FORM P3: ADMINISTRATIVE DECISIONS AND MINOR AMENDMENTS

RE: Hotel Wyndham Property Changes

HOTEL WYNDAM CHANGES - CHANGE OF USE
2500 CARLISLE BLVD NE
ALBUQUERQUE, NM 87110

Project# PR-2018-001580
Application# SI-2018-0000153- Site Plan DRB

18007 AS101

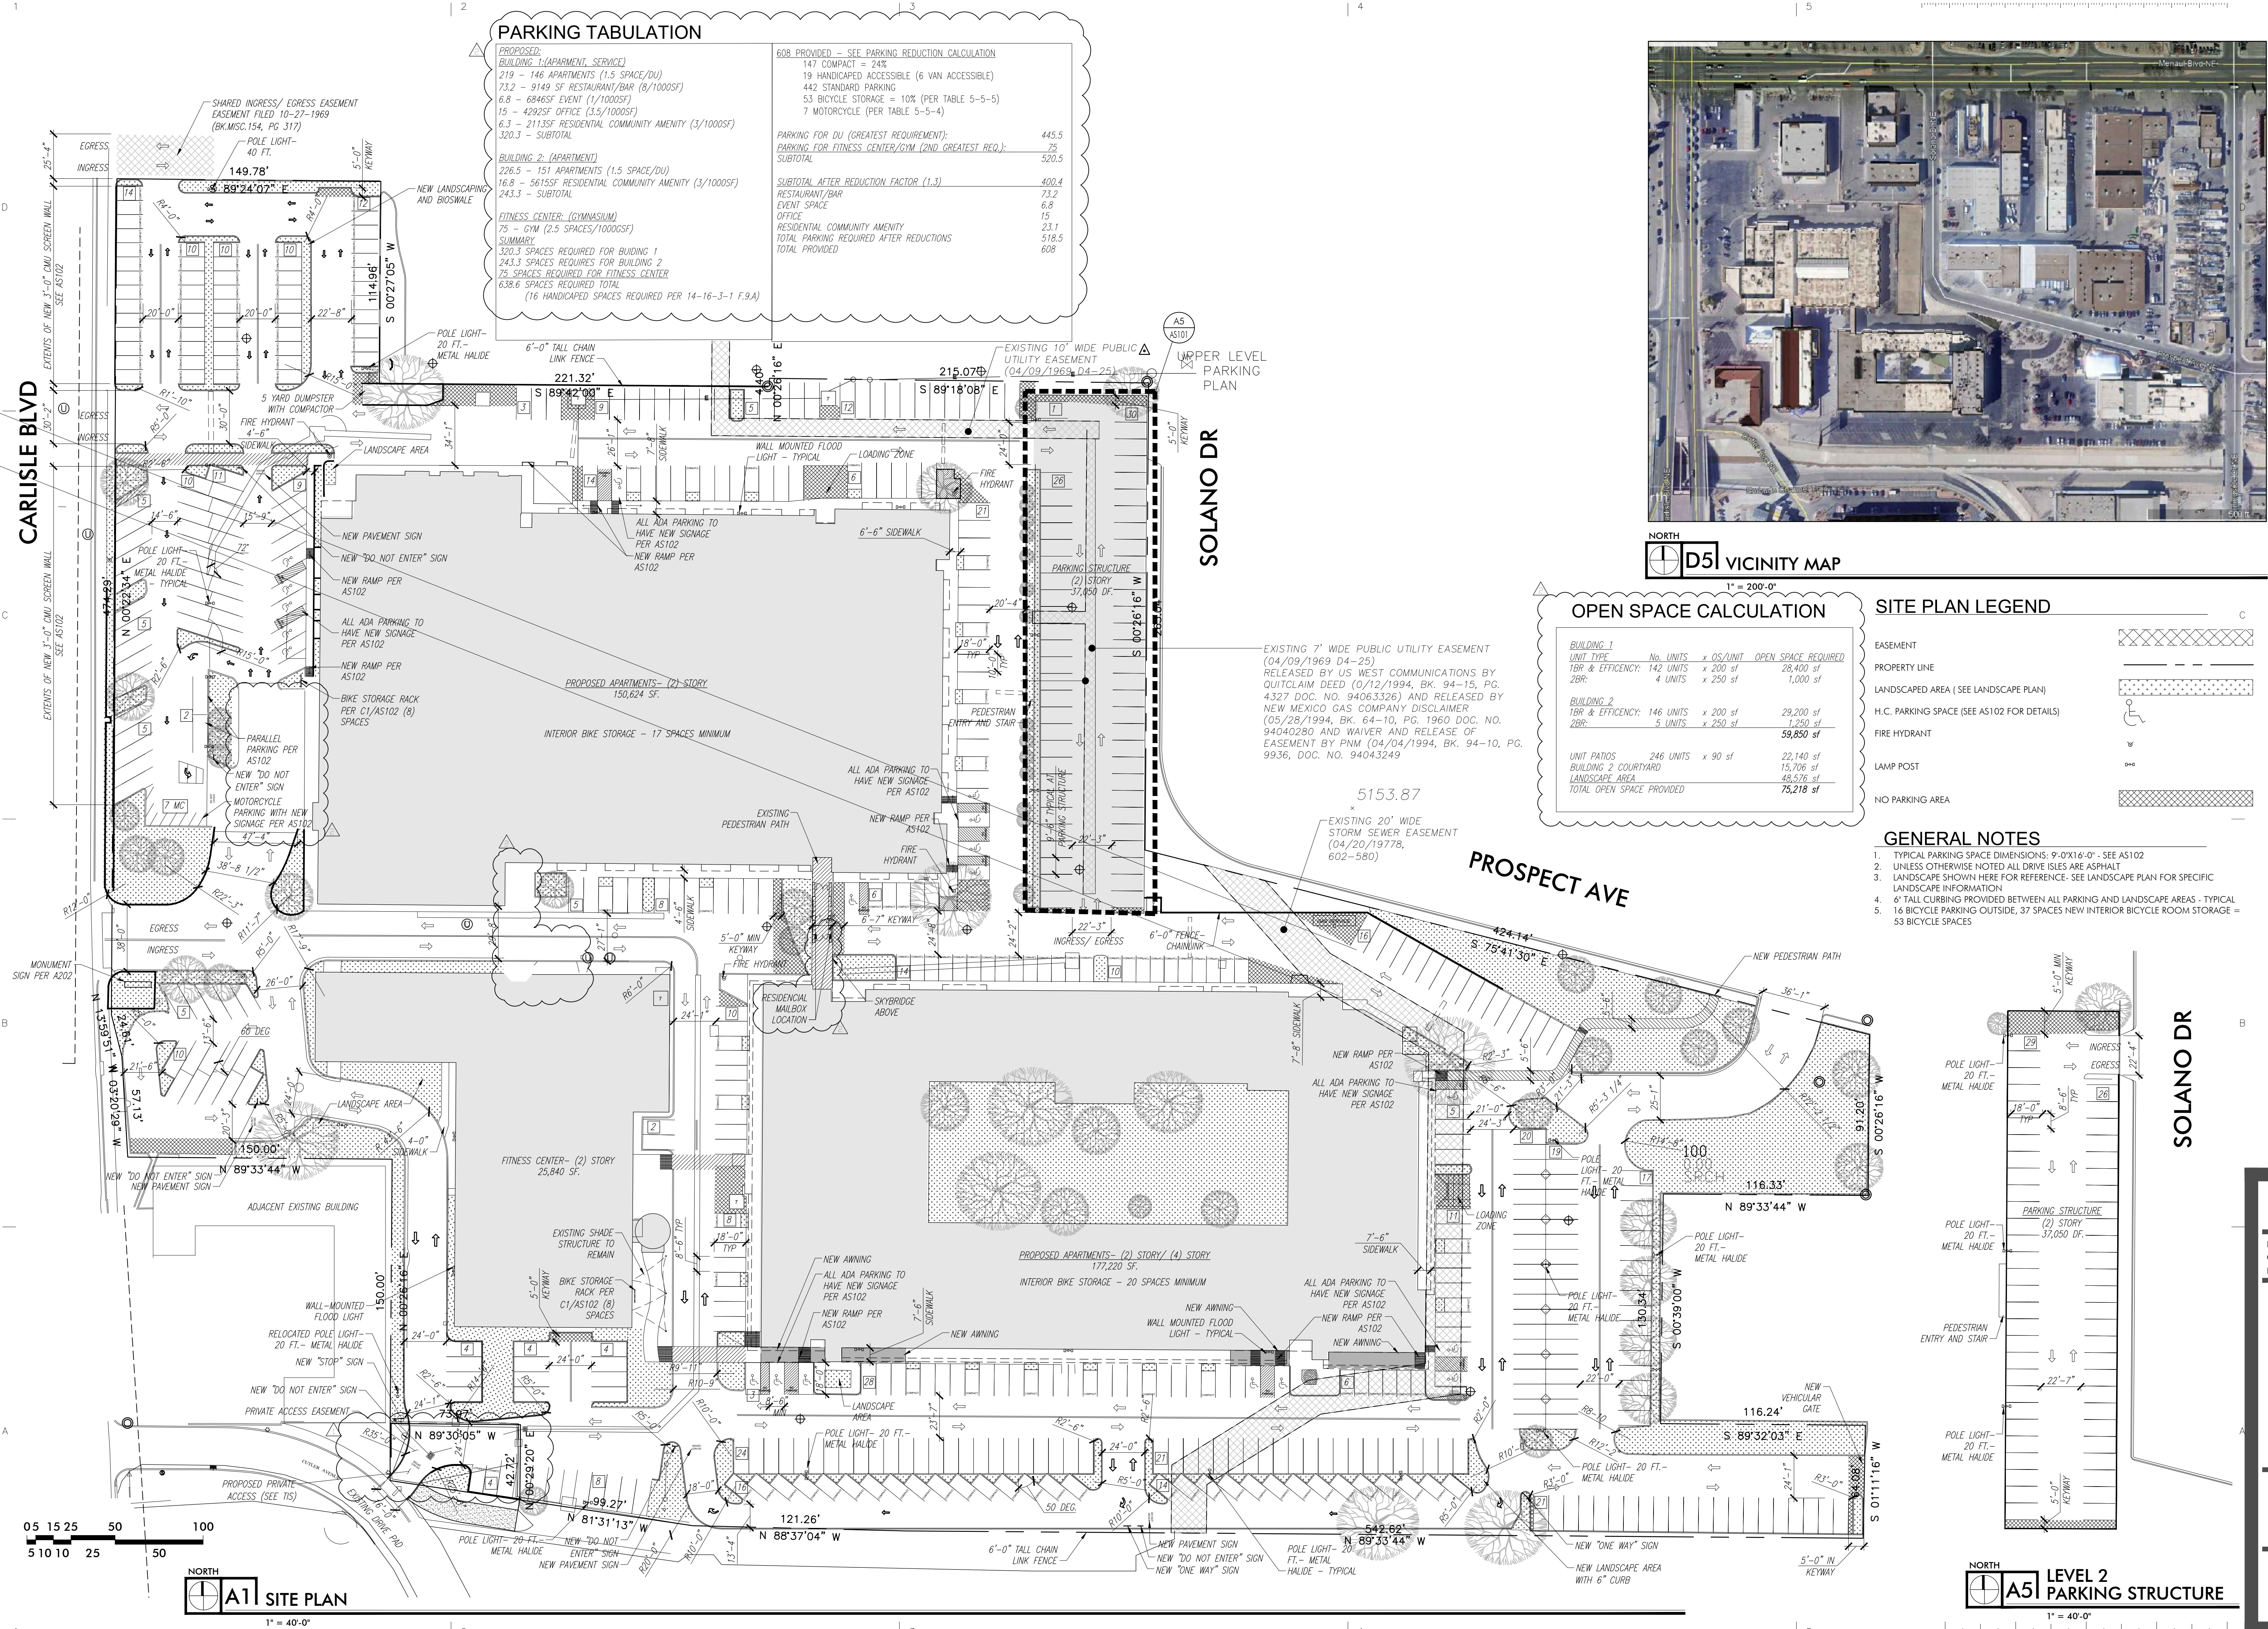
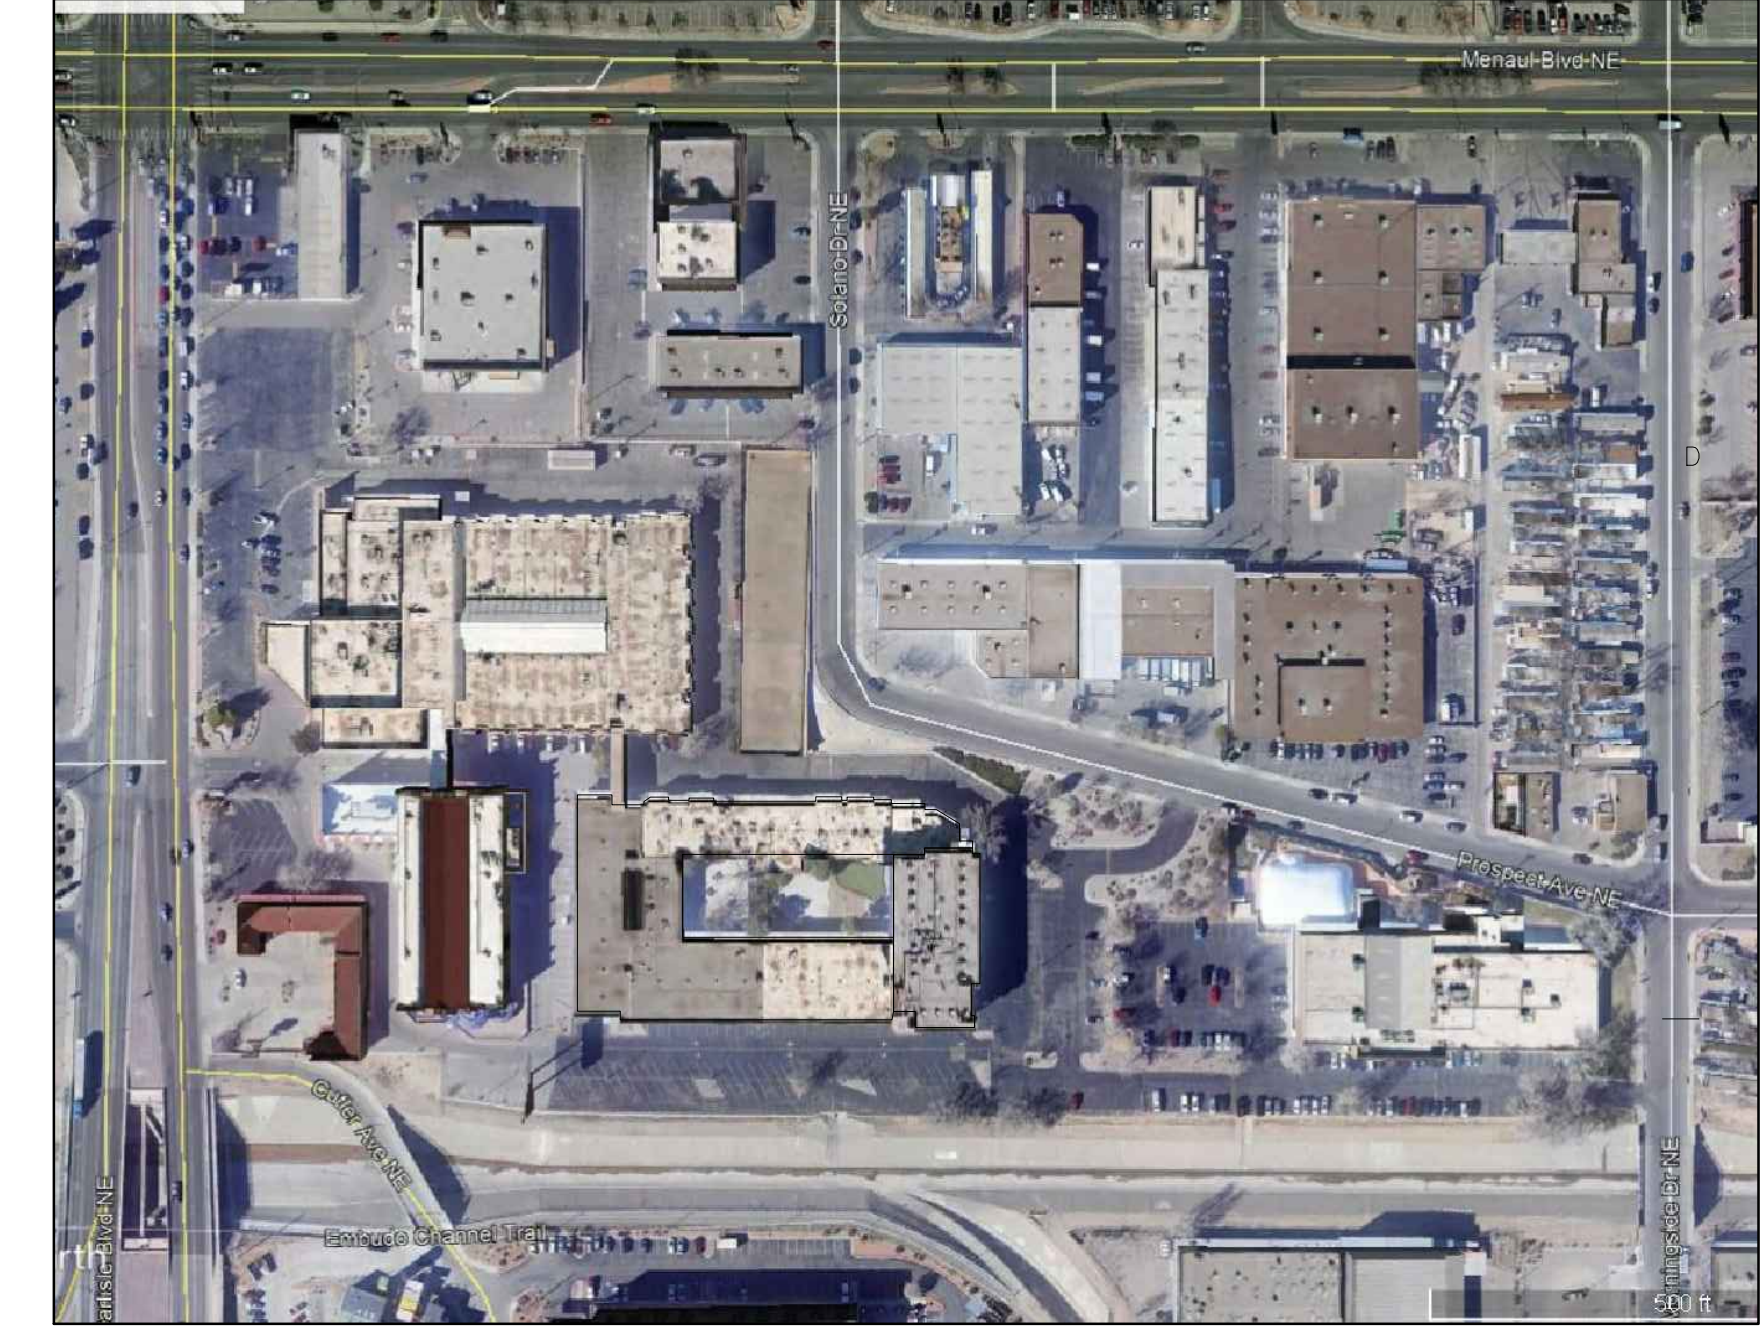
BUILDING 1: (APARTMENT SERVICE)
 219 - 148 APARTMENTS (1.5 SPACE/DU)
 73.2 - 9149 SF RESTAURANT/BAR (8/1000SF)
 6.8 - 6846SF EVENT (1/1000SF)
 15 - 4292SF OFFICE (3.5/1000SF)
 6.3 - 2113SF RESIDENTIAL COMMUNITY AMENITY (3/1000SF)
 320.3 - SUBTOTAL

BUILDING 2: (APARTMENT)
 226.5 - 151 APARTMENTS (1.5 SPACE/DU)
 16.8 - 5615SF RESIDENTIAL COMMUNITY AMENITY (3/1000SF)
 243.3 - SUBTOTAL

PARKING FOR DU (GREATEST REQUIREMENT): 445.5
PARKING FOR FITNESS CENTER/GYM (2ND GREATEST REQ.): 75
SUBTOTAL: 520.5

SUBTOTAL AFTER REDUCTION FACTOR (1.3): 400.4
 RESTAURANT/BAR: 73.2
 EVENT SPACE: 6.8
 OFFICE: 15
 RESIDENTIAL COMMUNITY AMENITY: 23.1
TOTAL PARKING REQUIRED AFTER REDUCTIONS: 518.5
TOTAL PROVIDED: 608
